# CULTURAL RESOURCES OFFICE PRESERVATION BOARD

REGULAR MEETING MONDAY JUNE 28<sup>TH</sup>, 2010 1015 LOCUST ST. #1200 4:00 P.M.

PRE	ELIMINARY REVIEWS		PG
<b>A</b> .	6044 CATES AVE.	PRESERVATION REVIEW DISTRICT	1
B.	20 N. 20 <sup>TH</sup> ST.	ST. LOUIS CITY LANDMARK	8
C.	1918 KENNETT PLACE	LAFAYETTE SQUARE HISTORIC DIST.	16
D.	6120 DELMAR BLVD.	SKINKER-DeBALIVIERE HISTORIC DIST.	19
APP	PEALS OF STAFF DENIALS		
E.	4722 McPHERSON AVE.	CENTRAL WEST END HISTORIC DISTRICT	26
F.	2229 CALIFORNIA AVE.	FOX PARK HISTORIC DISTRICT	30
G.	2738 ACCOMAC ST.	FOX PARK HISTORIC DISTRICT	36
Н.	1959 ARSENAL ST.	BENTON PARK HISTORIC DISTRICT	40
I.	<b>2653 OHIO AVE.</b>	ST. LOUIS CITY LANDMARK	45
NEV	W APPLICATION		
J.	2005 VICTOR ST.	BENTON PARK HISTORIC DISTRICT	51

LOCATION OF NEW STANDARDS

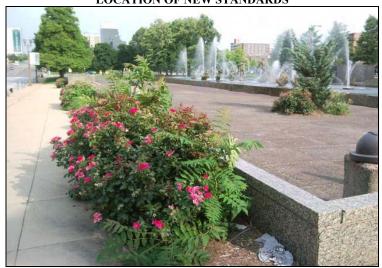
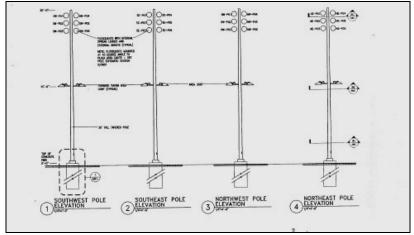
The new standard design has reduced the number of light fixtures and is much lighter and more elegant in form than the original proposal. The designers have agreed to have a lighting test prior to final installation to ensure that the effect upon the Fountain is subtle and atmospheric. The Cultural Resources Office will be included in the committee to approve the final lighting scheme.

The Cultural Resources Office staff recommends that the Preservation Board grant preliminary approval to the revised light standards, with the stipulation that a plan be created to address future restoration of the existing in-pool lights.

**PROPOSAL**

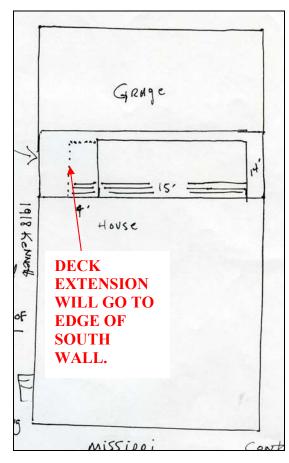
Does Not Comply: The handrail of the deck will be visible from the street.

The new handrail will extend two to three feet above the parapet on the Kennett side of the building. When originally constructed, the roof deck was purposefully designed to be away from the edge of the building to conform to the standards.

The Cultural Resources Office recommends that the Preservation Board deny the preliminary application as the proposal is not in compliance with the Lafayette Square Standards.

PROPOSED SIGN DESIGN WITH READER BOARD

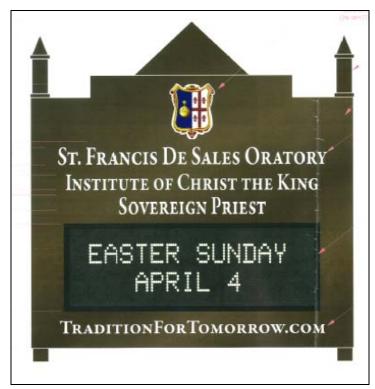
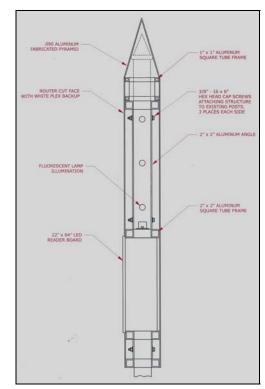
There are no Standards included in the St. Francis de Sales Landmark designation, and therefore the Preservation Board should consider this application with respect to its impact on the significant architectural and historic character of the Church.

That the Preservation Board uphold the Cultural Resources Office denial of the sign as proposed.
